**WILSONVILLE CITY HALL
DEVELOPMENT REVIEW BOARD PANEL B**

A. Resolution No. 322.

Universal Health Services: Universal Health Services, Inc., Willamette Valley Behavioral Health- Applicant. The applicant is requesting approval of an Annexation of territory, a Comprehensive Plan Map Amendment from Washington County - Future Development - 20 District (FD-20) designation to City - Industrial designation, a Zone Map Amendment from Washington County - Future Development - 20 District (FD-20) to City - Planned Development Industrial - Regional Significant Industrial Area (PDI-RSIA) zone, a Stage I Preliminary Development Plan, Waivers, Stage II Final Plan, Site Design Review, Type C Tree Plan and Signs for an 8.72 acre site. The subject site is located on Tax Lots 400, 500 and 501 of Section 2B, Township 3 South, Range 1 West, Willamette Meridian, City of Wilsonville, Washington County, Oregon.

Documents: [UHS Staff Report.Exhibits.pdf](#), [Exhibit B1.pdf](#)

A SITE LIGHTING PLAN
 E-300 SCALE: 1/32" = 1'-0"

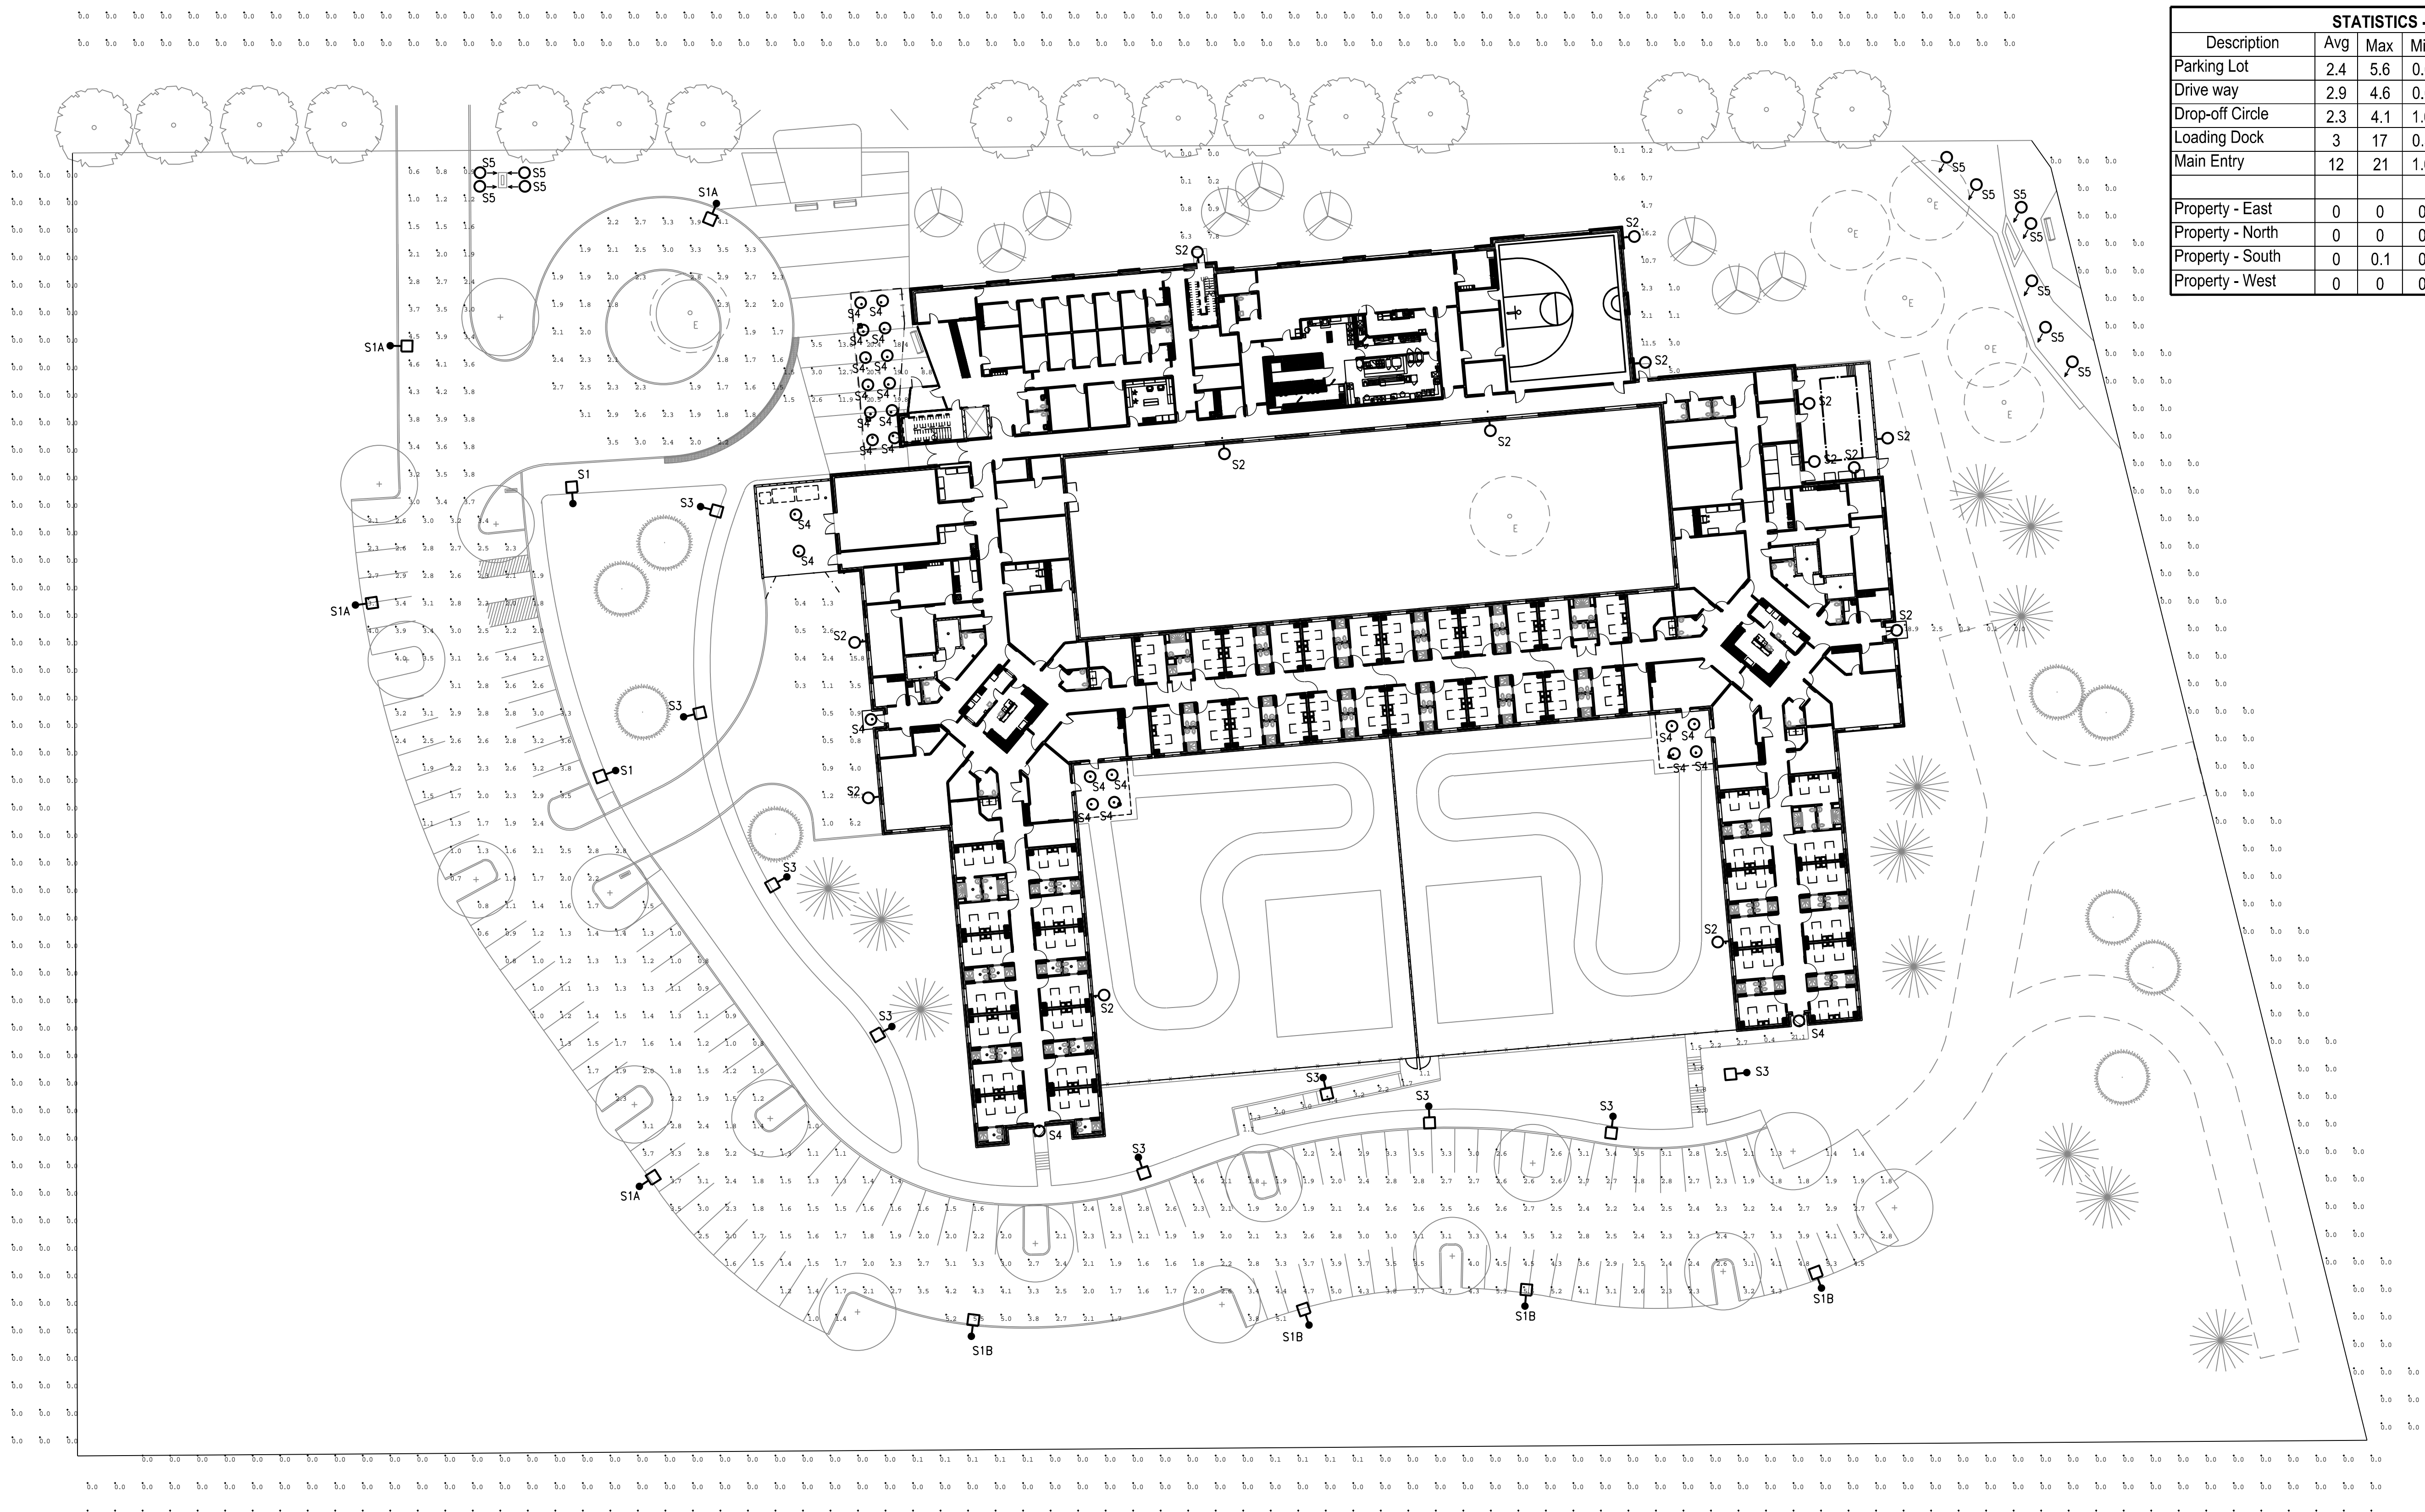
Details of Finding: The applicant has elected to comply with the Performance Option and is demonstrated in the lighting plans shown in Exhibit K of Exhibit B1.
